# County of Fairfax, Virginia

## **STAFF REPORT**

**RZ/FDP 2011-PR-025**

**PROPOSAL:** The applicant seeks to rezone the subject property to PDH-8 and HC and approval of a conceptual and final development plan to permit the development of 46 single-family attached townhouses and seven single-family detached units.

**Drawing Title**  
CDP/FDP LAYOUT

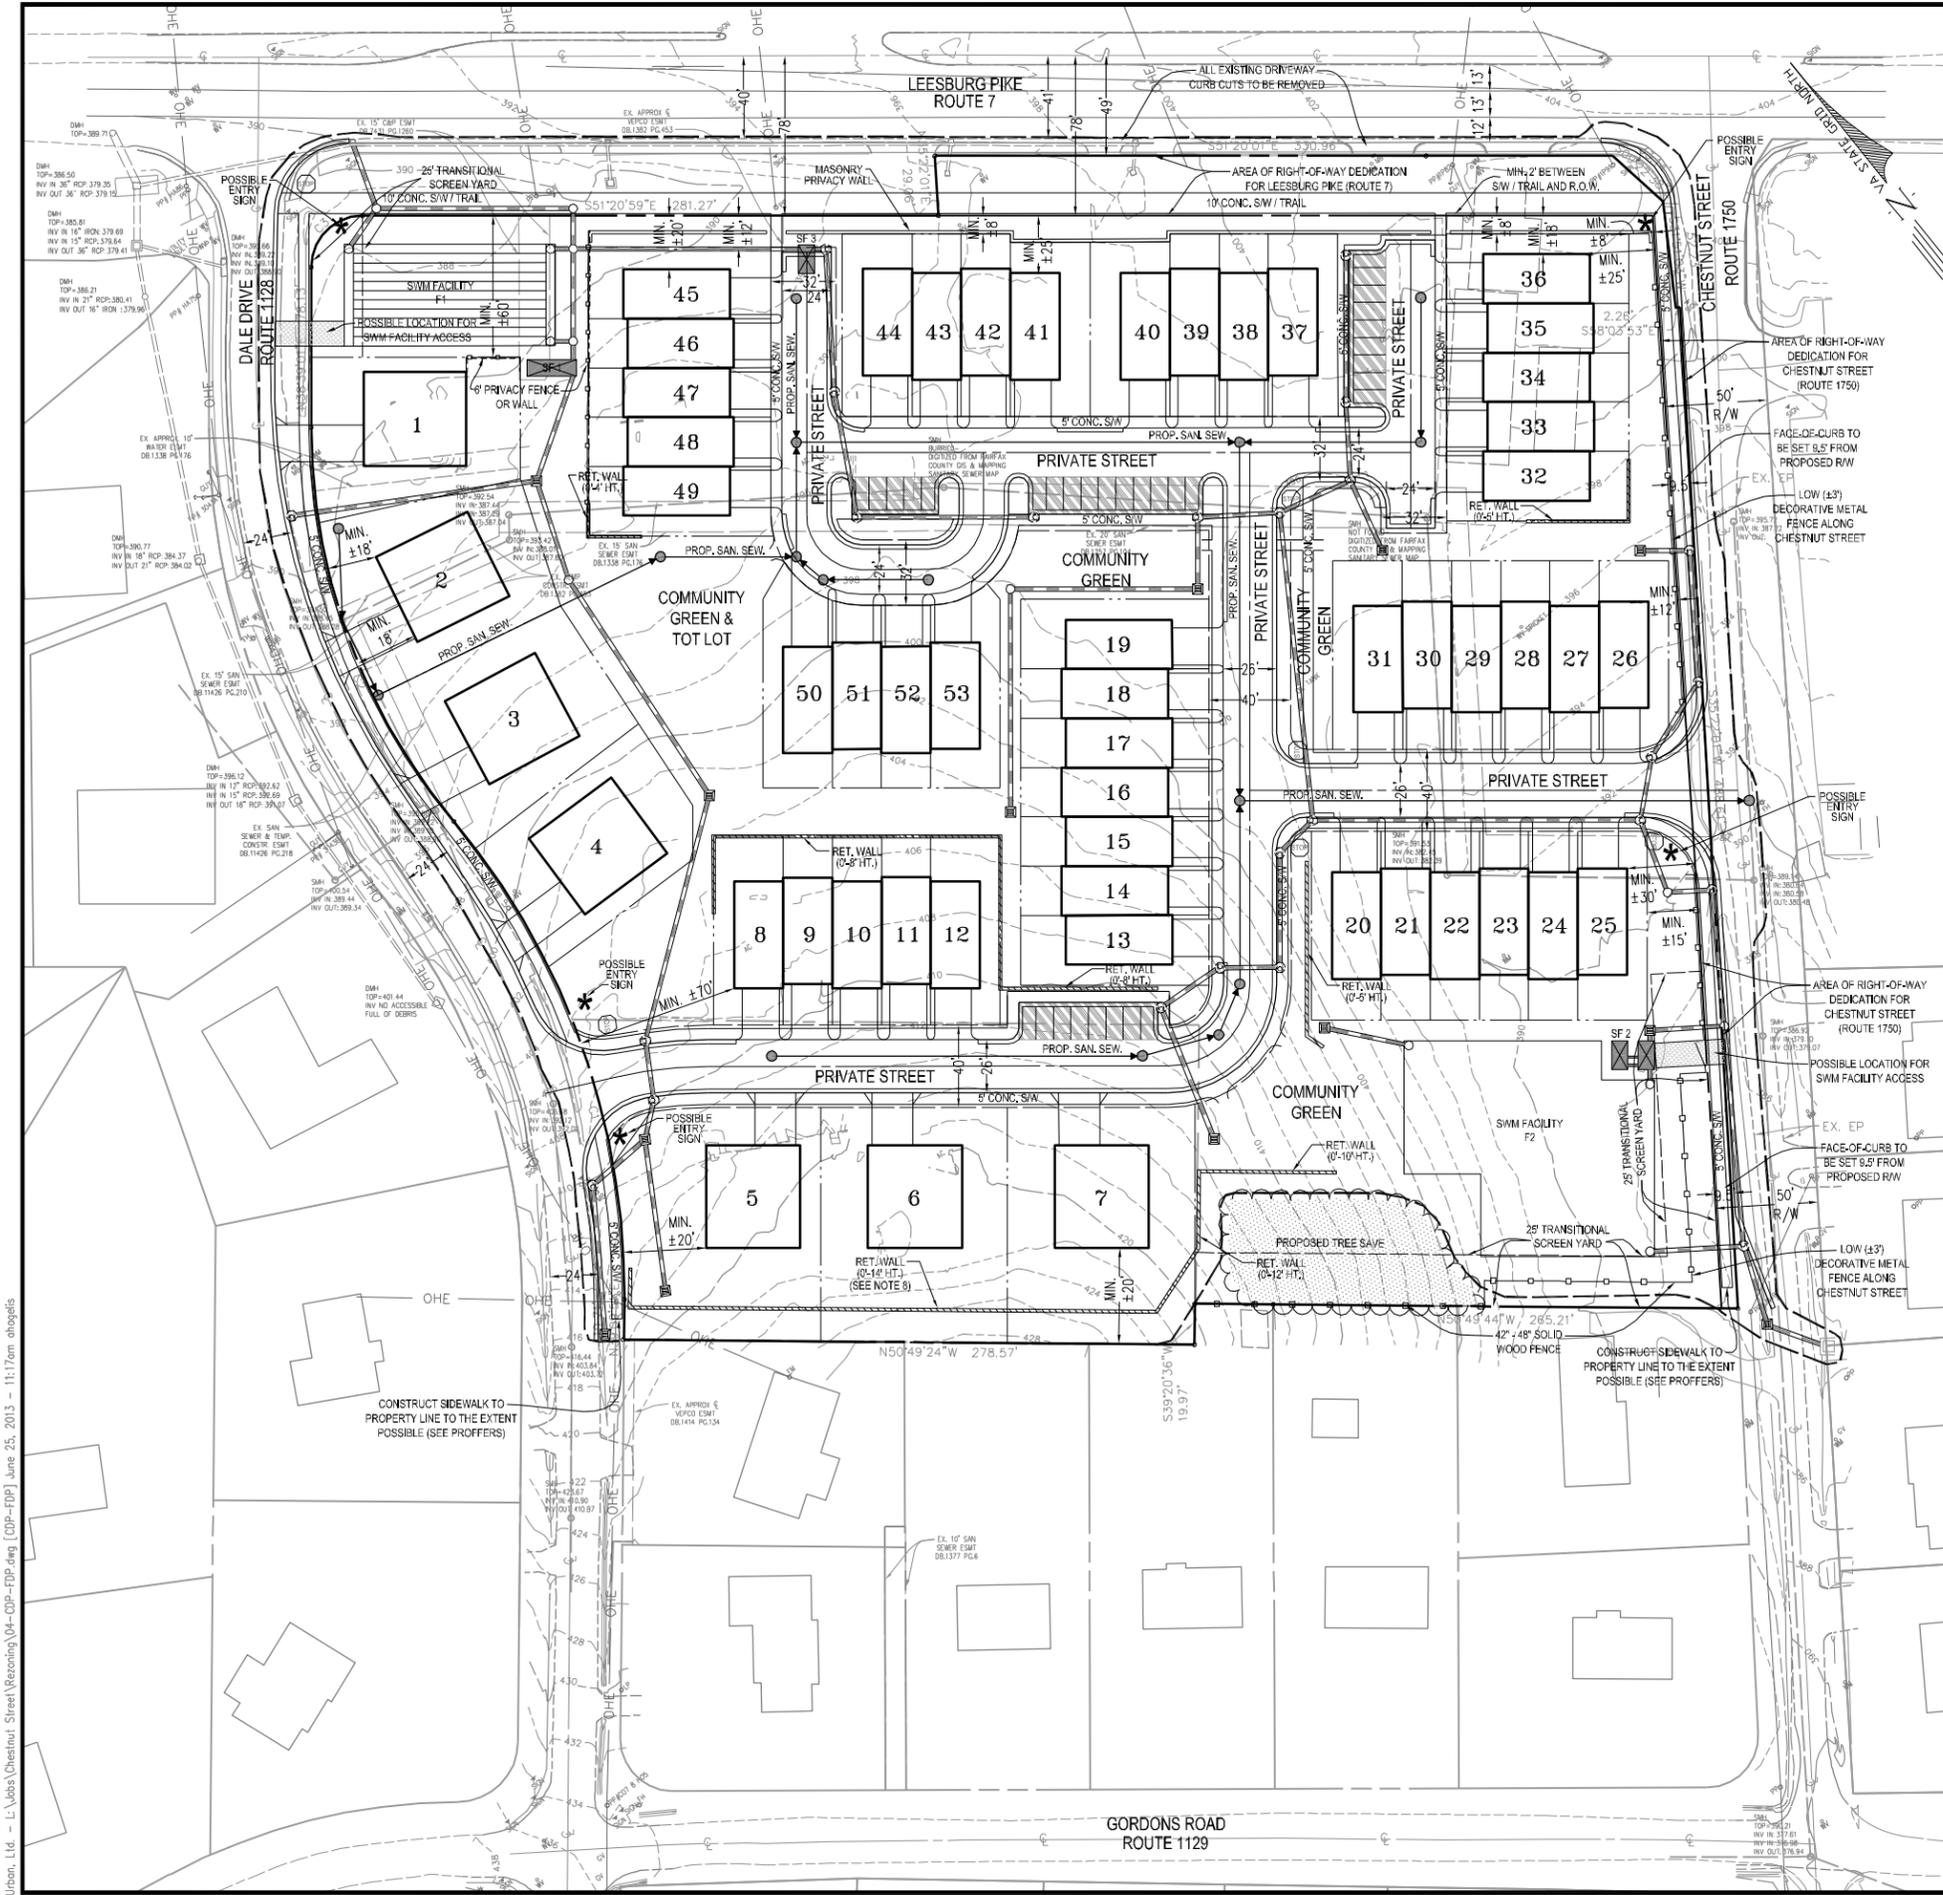
Staff has commented that the proposed 25 foot transitional screen along the southern property line near Chestnut Street does not meet the Ordinance requirements. The vegetation in the tree save area identified on the plans contains mature tulip poplar trees that do not provide a screen at eye level. Additional understory plantings are recommended including a mix of category I and category II evergreen trees and evergreen shrubs to meet the intent of the transitional screening requirement. The applicant has submitted revised plans that include additional understory plantings in this location. In addition, a development condition is proposed to require conformance with this recommendation. With the adoption of this condition, this issue is addressed.

There are two trees shown to be planted on top of a proposed utility pipe located to the west of lots 16 and 17. The applicant has submitted a revised plan that has rectified this condition.

**Drawing Title**  
ILLUSTRATIVE ARCHITECTURE

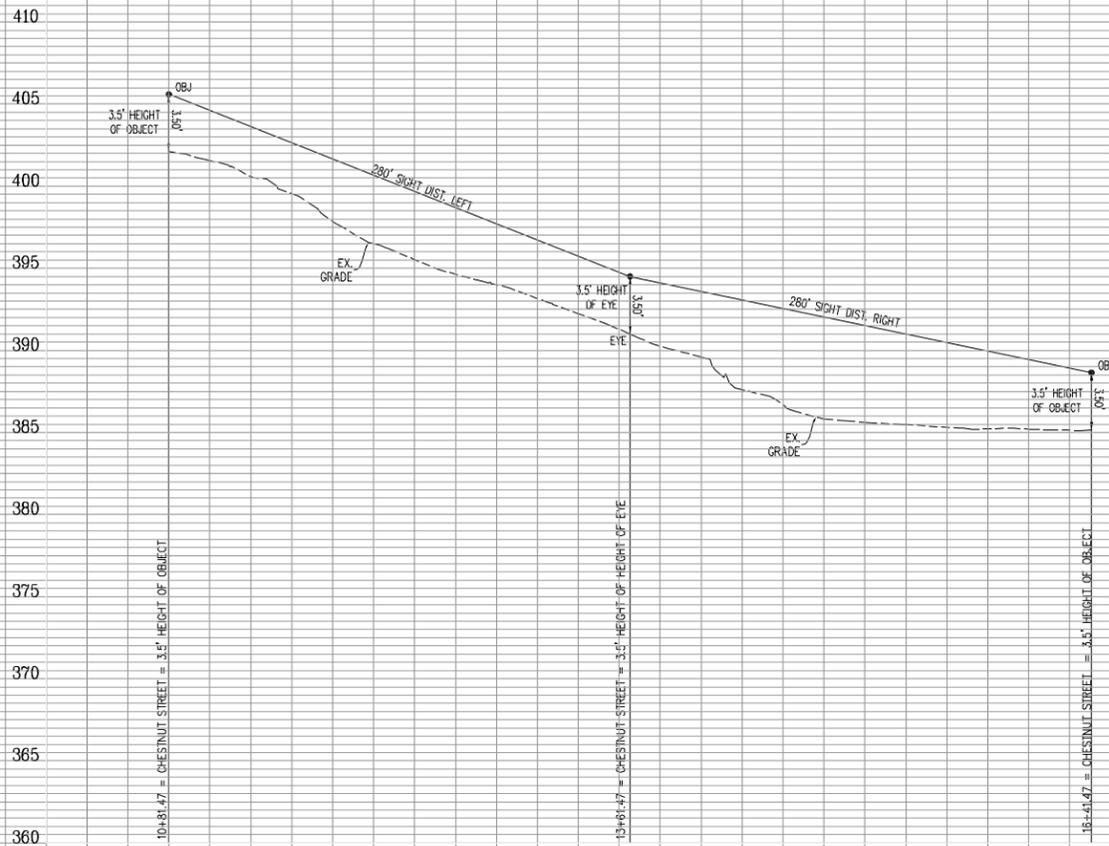
Sample architectural building types have been provided on Sheet 12 of the CDP/FDP. The townhouses and single-family detached units included in the photographs have a colonial style with brick and stone facades, dormer windows, and shutters. A proffer has been provided that requires that the design be generally consistent with these images and requires the use of brick and generous fenestration. The proffer further provides that the rear facades of the units which face public streets will receive the same architectural treatment as the front facades, in addition to the single-family attached end-units. Staff recommends that Craftsman style architecture that is more consistent with adjacent new development to the west be incorporated in the design. This is discussed in greater detail with the residential development criteria below.

**Drawing Title**  
SIGHT DISTANCE PROFILE

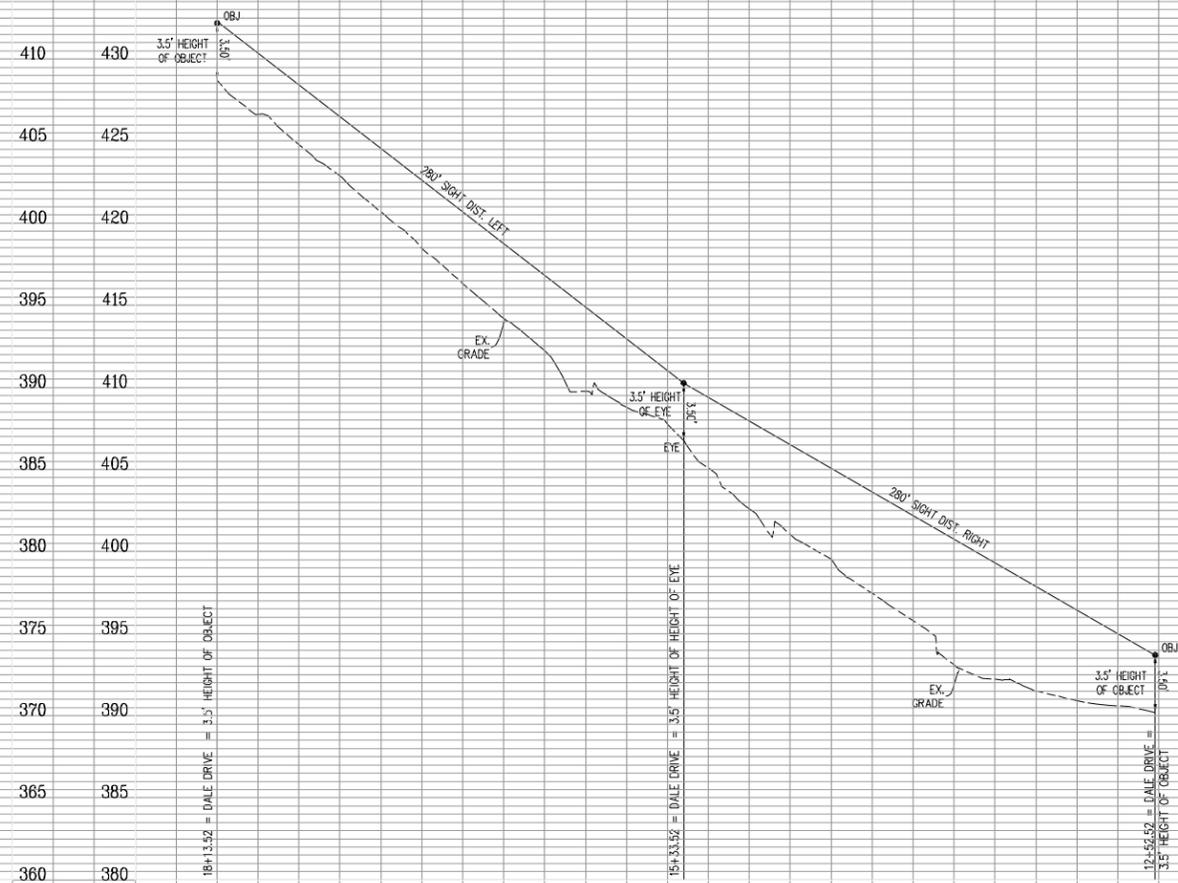
The CDP/FDP shows one vehicular access point from Dale Drive and one from Chestnut Street. A sight distance profile is provided on Sheet 13 that demonstrates both access points meet VDOT standards. An internal network of three private streets measuring between 24 and 26 feet in width provides for vehicular and pedestrian circulation within the development. Given these widths, no on-street parking would be permitted. The street network has been designed with an intentional offset to discourage through traffic from traversing the site from west to east from Dale Drive to Chestnut Street. The private street at the north end of the site has a "U"-shaped configuration that terminates in two hammerheads. All units are front-loaded with garages and driveways that front on the private streets. Five-foot wide concrete sidewalks are provided on both sides of all the private streets in addition to sidewalks along Dale Drive and Chestnut Street and a ten foot wide concrete trail along Leesburg Pike.

Figure 2 - Site Layout

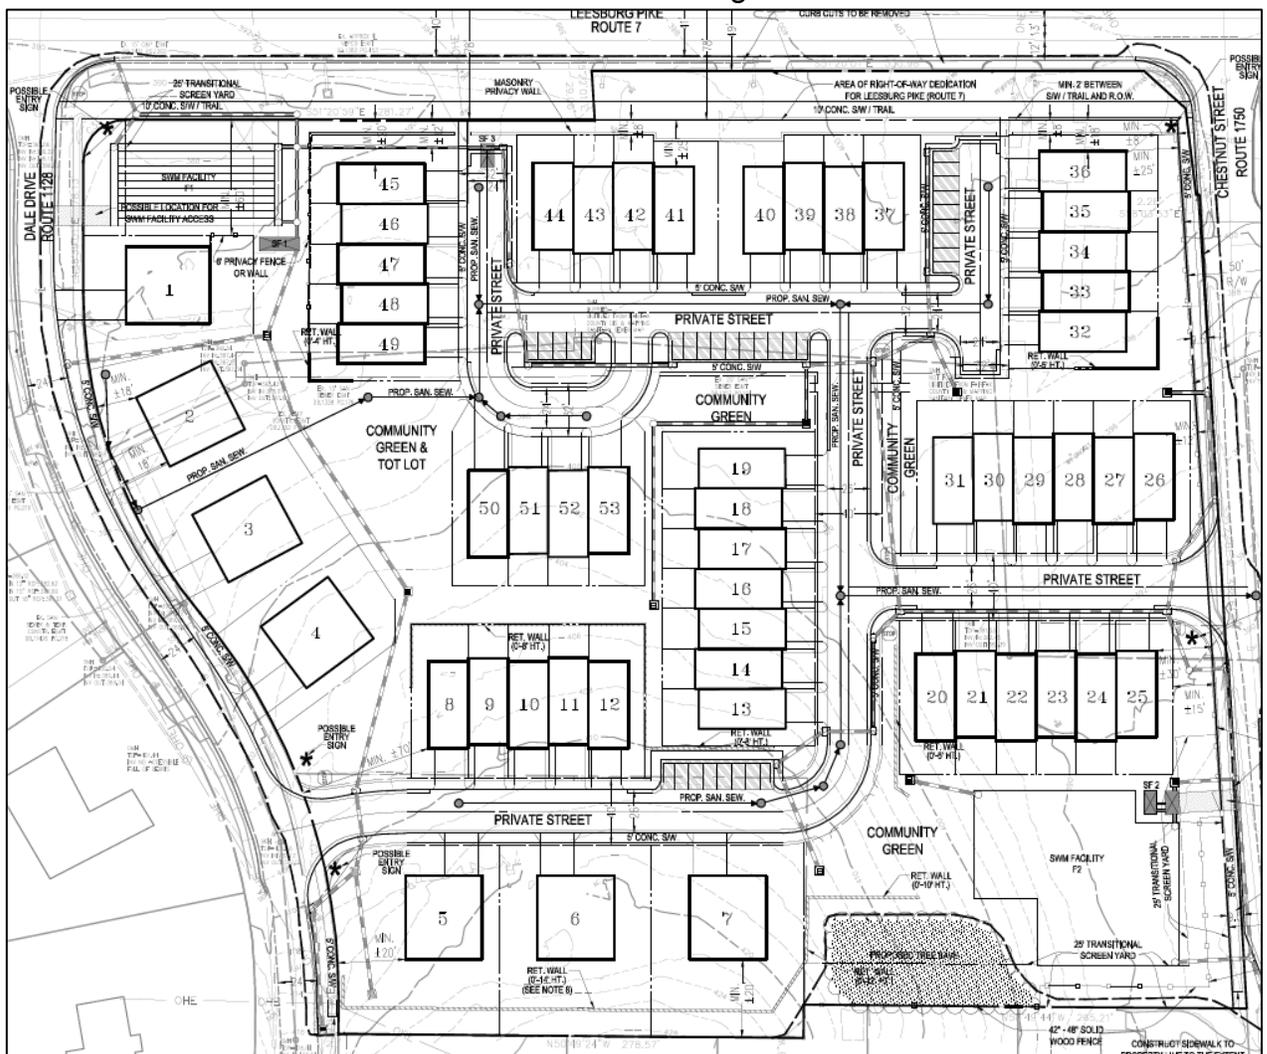
The applicant's CDP/FDP (see Figure 2) situates the townhouses facing inward to the development in rows of four to seven units along a series of three private streets. The units are shown at 24 feet in width with minimum 18 foot front setbacks and 15 foot rear setbacks. Thirty-two guest parking spaces are provided in parking areas distributed throughout the site, in addition to garage and driveway spaces. The seven single family units are shown at the western and southern edges of the property along Dale Drive and the southern property line on lots of between 7,000 to 9,000 square feet with minimum setbacks of 18', 20', and 6', for the front, rear, and side yards, respectively. Four common open space areas are provided throughout the development. The open space at the western end of the site would contain a tot lot or active recreation feature. The other spaces provide for passive seating areas. Stormwater would be accommodated by two subsurface detention facilities located at the northwest and southeast corners of the site. A small tree save area is shown adjacent to Lot 7. A masonry wall that also functions as a sound wall is shown along Leesburg Pike. The location for two possible entry signs are depicted at the Dale Drive and Chestnut Street corners with Leesburg Pike.

Figure 3 – Community Green/Stormwater area

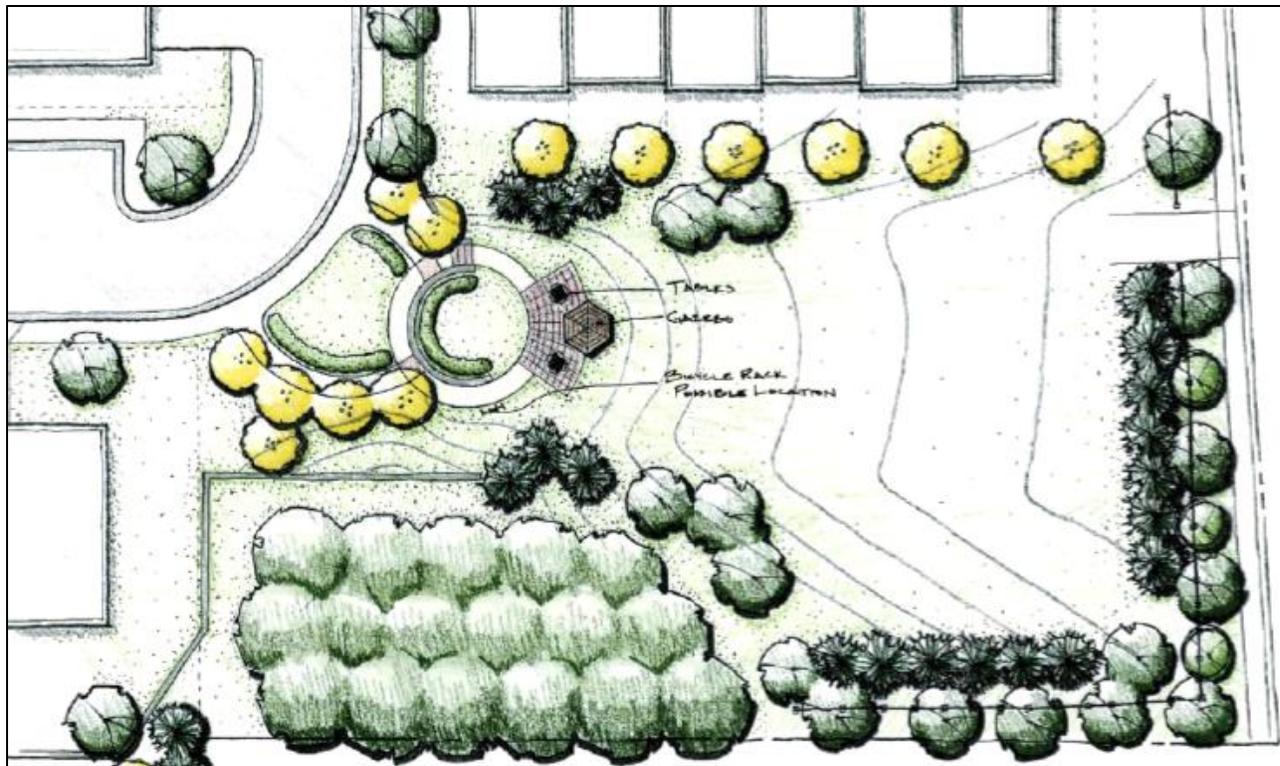
The Zoning Ordinance requires a minimum of 25% open space for the 7.86 acre site; 25.4% (1.91 acres) is being provided, primarily through four open space areas and a small tree save area. Sheets 6 and 11 of the CDP/FDP show the proposed landscape design. The open space areas are identified as "community greens" on the CDP/FDP. The largest of these is located at the southeastern corner of the site, adjacent to one of the sub-surface stormwater detention facilities. The detail for this space shows a gazebo, tables, and benches accented by shrub and tree plantings. A tot-lot and seating area are provided in the northwestern portion of the site, to the rear of the single-family detached units on Dale Drive. Access to this space is from the private street between two rows of townhouses. Two additional open space areas are provided on either side of the north-south oriented private street. These areas are smaller and provide passive seating areas, trellises, and a small rectangular-shaped lawn area.

Figure 4 – Detail of Tot Lot

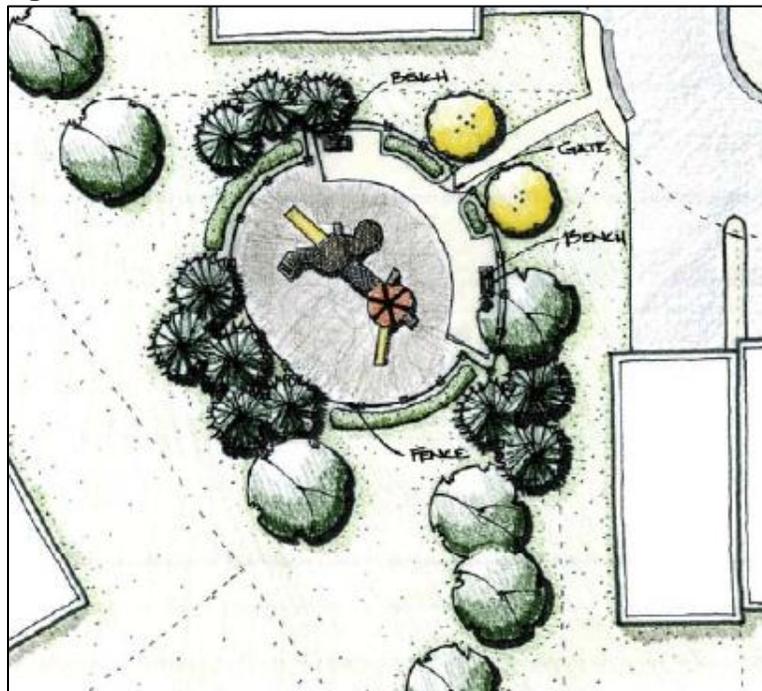
FCDOT has requested that three bicycle racks be provided adjacent to the community open spaces. The applicant has provided a revised plan that includes bicycle racks in the details of the open space areas. As such, this issue has been addressed.
